ORDINANCE NUMBER 2016-09

AN ORDINANCE OF THE TOWN OF PARADISE VALLEY,
ARIZONA AMENDING THE PARADISE VALLEY ZONING
ORDINANCE, Article XXII, HILLSIDE DEVELOPMENT
REGULATIONS

Comment [GB1]:
RED TEXT IS DRAFT LANGUAGE
PRESENTED TO PC AT 12/20/16 MEETING.

YELLOW HIGHLIGHTED TEXT IDENTIFIES
UPDATED LANGUAGE TO BE REVIEWED
AT 1/3/17 PC MEETING

FIGURE 2 – HILLSIDE DEVELOPMENT AREA

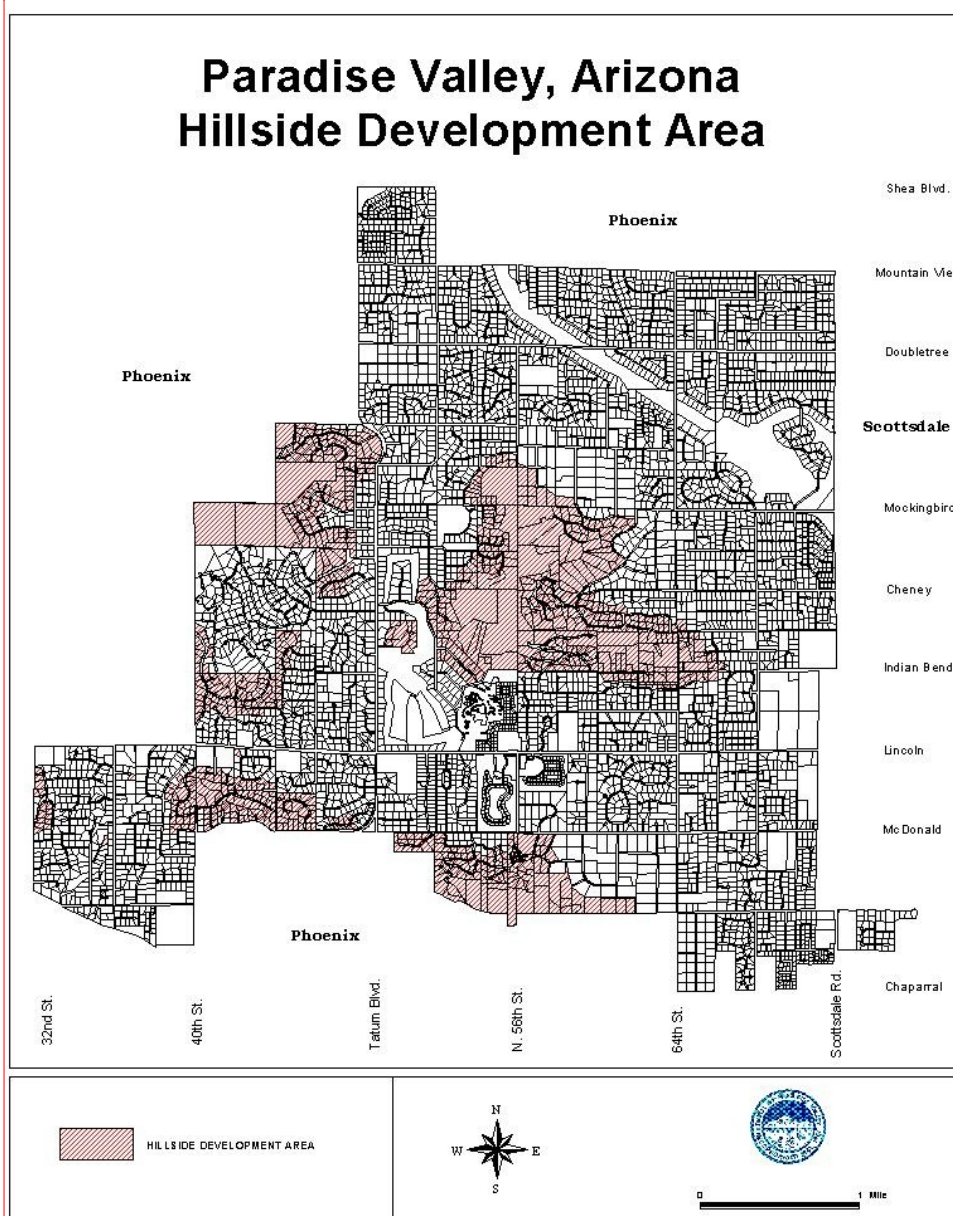
Comment [GB2]: Identify Process to Update Map with any properties removed from Hillside or added to Hillside

FIGURE 5 – BUILDING HEIGHT IN HILLSIDE

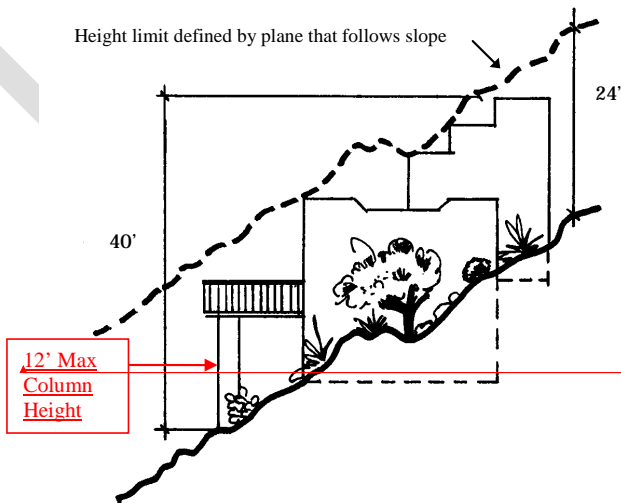
- iii. The maximum overall height of the building or structure, including chimneys and accessory buildings, shall not exceed forty (40) feet from the highest point of ~~the building to natural grade at the lowest point adjacent to the building structure or column~~of a building or structure to the lowest point of Natural Grade at the lowest building or structure (excluding driveway retaining walls) - (see FIGURE 5).

Comment [GB7]: Figure 5 to be updated to reflect these edits.

FIGURE 7 - HEIGHT FOR A CANTILEVERED ELEMENT

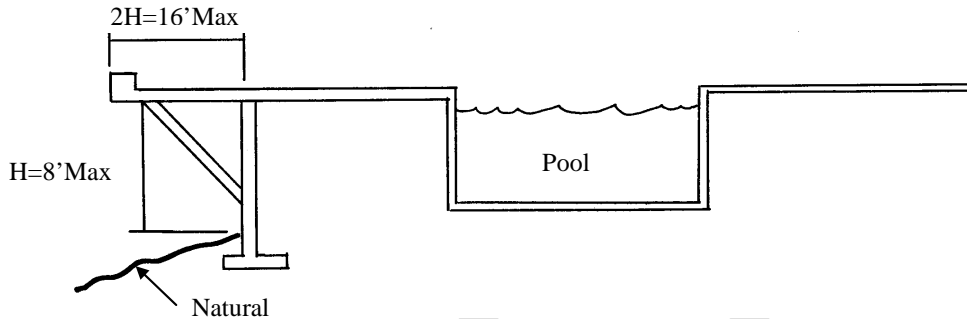
Comment [GB8]: There was no consensus on the 12/20/16 PC meeting regarding this topic. It was recommended that language be added to identify what the area under a cantilever should look like. Additional review and discussion is needed.

Comment [GB9]: New figures to be added to the code to illustrate these scenarios.

B. Structures employing the use of a cantilever may extend the cantilever a horizontal distance twice the height of the support. The maximum vertical height of the support shall be eight (8) feet. One half the area underneath the cantilevered element shall be calculated as disturbed area. (See FIGURE 7 below).

FIGURE 8 – TERRACED VERTICAL RETAINING WALLS

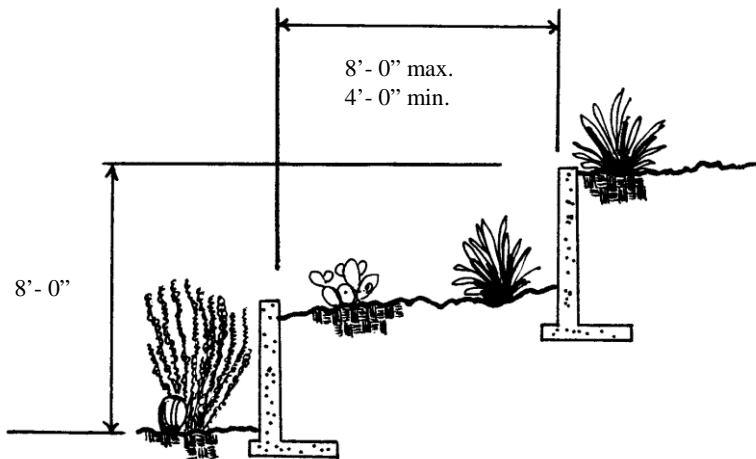
Comment [GB13]: Relocate Figure 8 below the text of 2207.VI.1.e.
